A G E N D A

Architectural Review Board

February 23, 2016

912 East Fairview Avenue

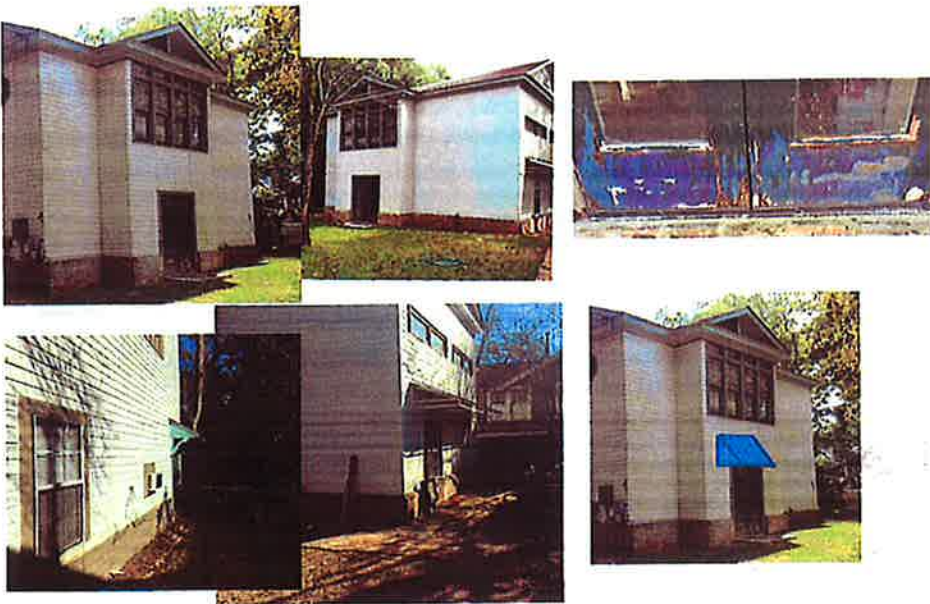
- The Board discussed the possibility of building a pergola to replace the iron structure when Mr. Riley previously appeared before the Board.

3245 LeBron Road

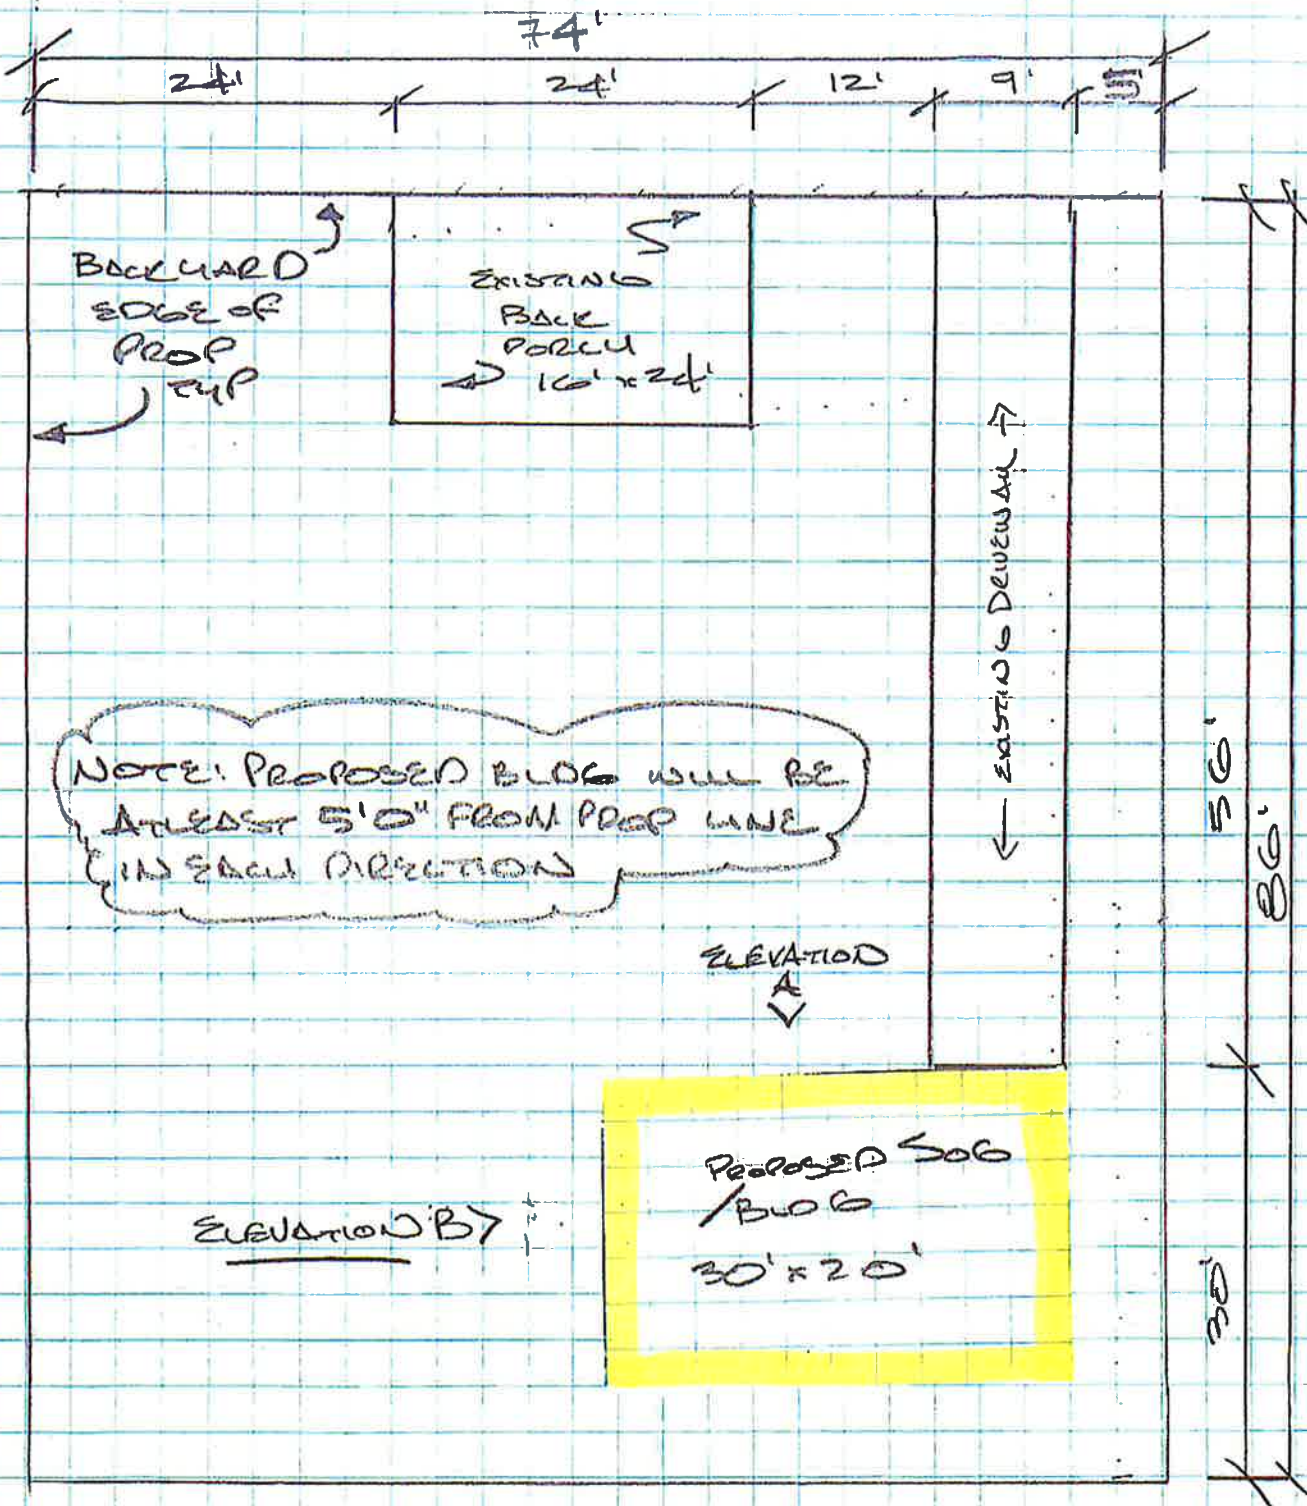
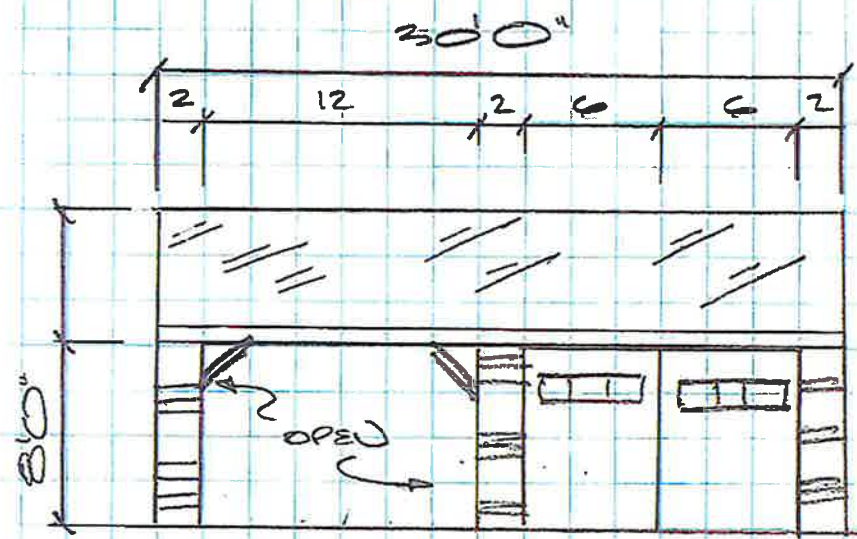
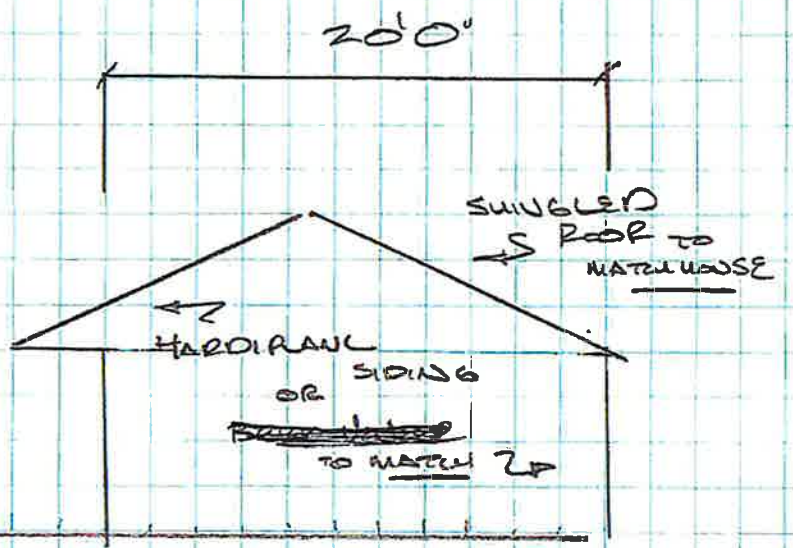
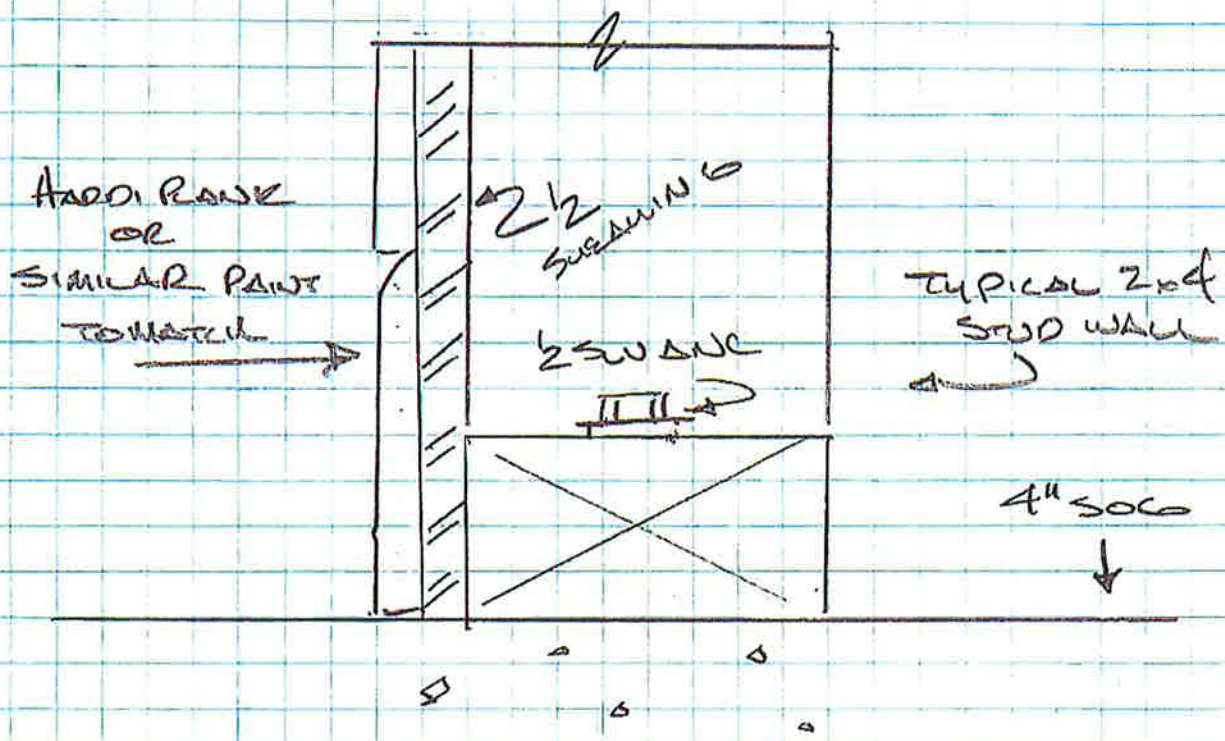
- As proposed, the use of lap siding with an overhanging eave is compatible with the historic district.
- The Board has approved garages and carports that were compatible; this is a combination of the two.

122 Commerce Street, Coosa and Bibb Street elevations

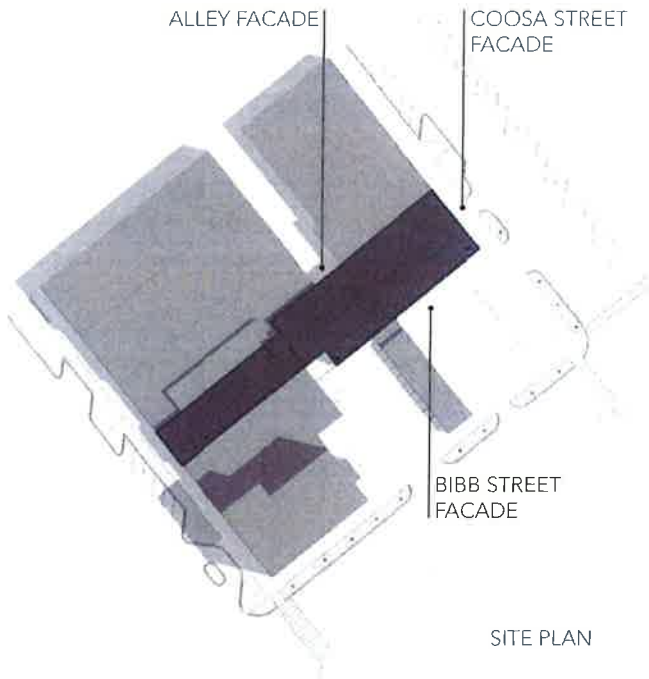
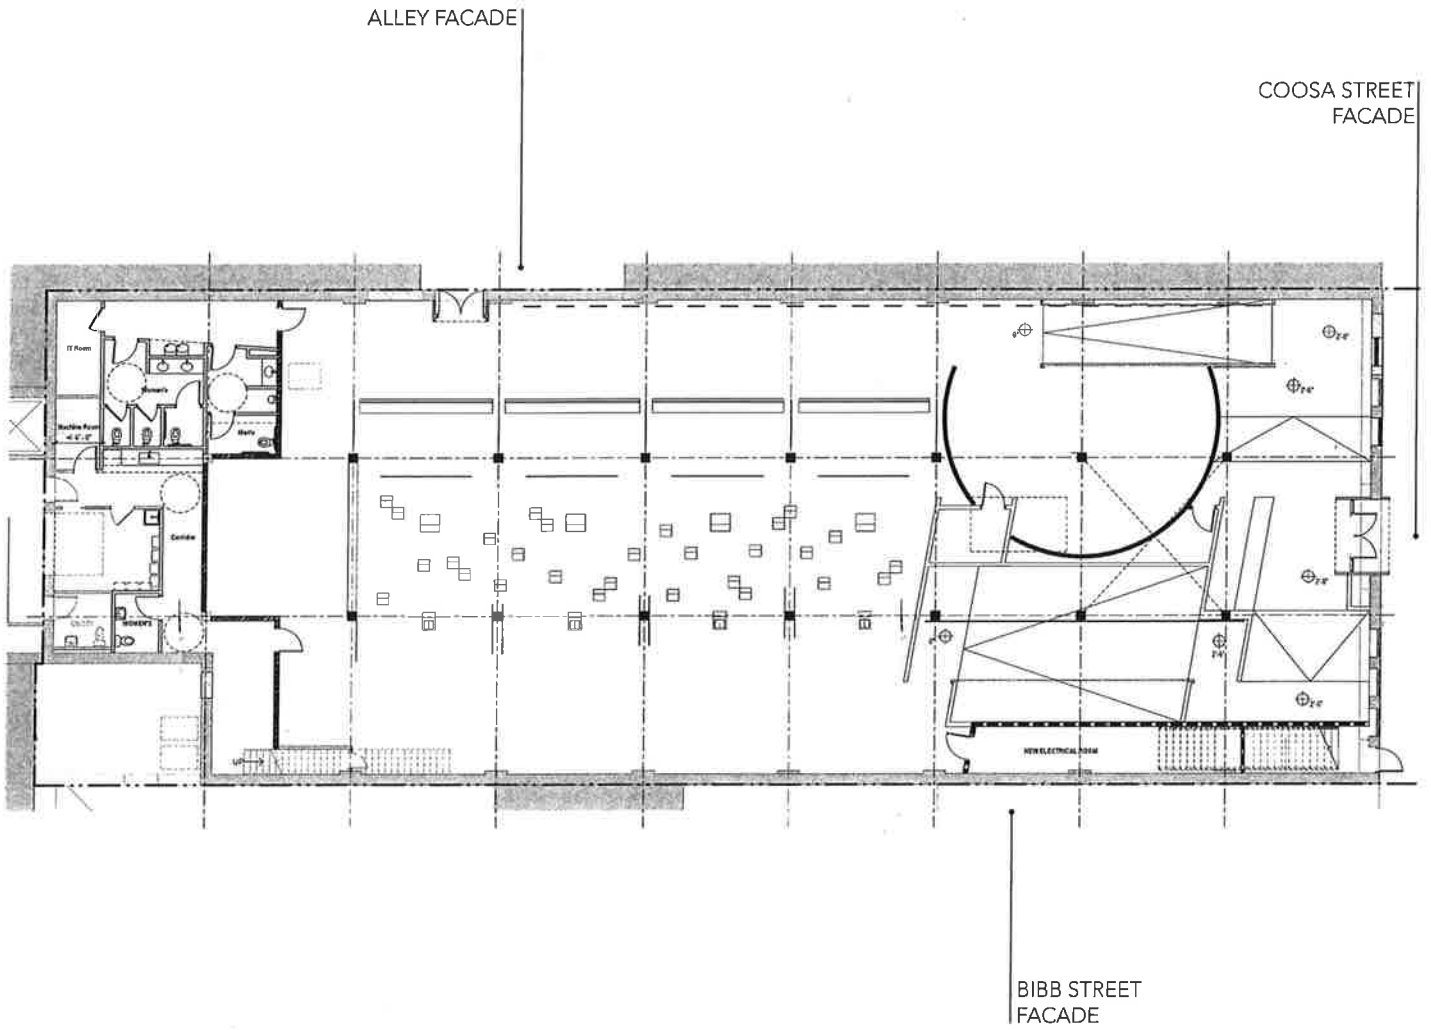
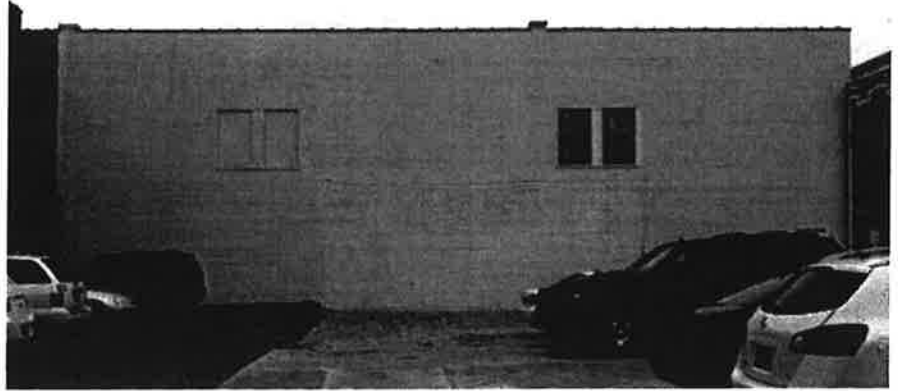
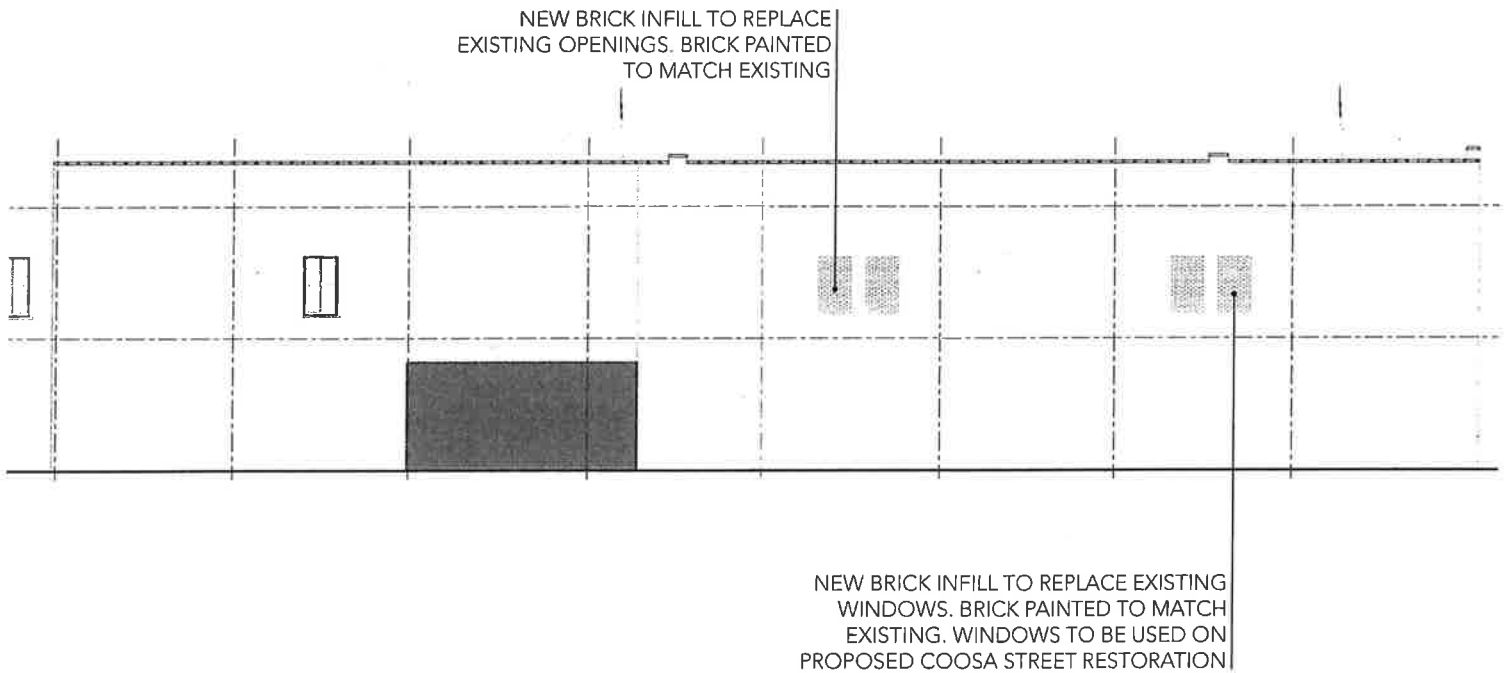
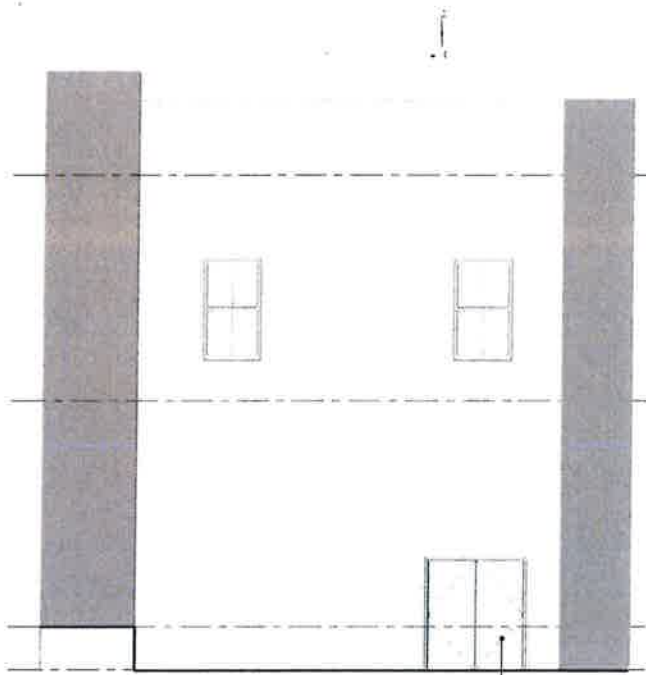
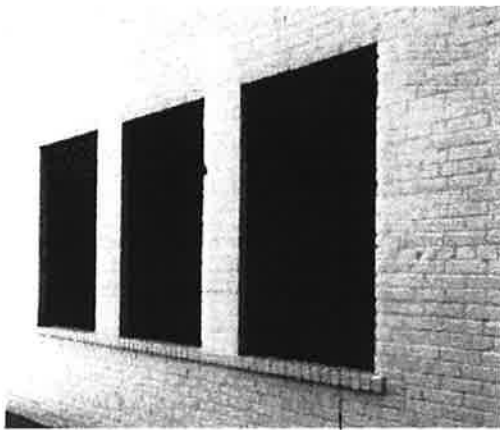
- The Board needs to determine if the proposed art installations are appropriate for a commercial historic district. SmartCode permits public art in T5 zoning.
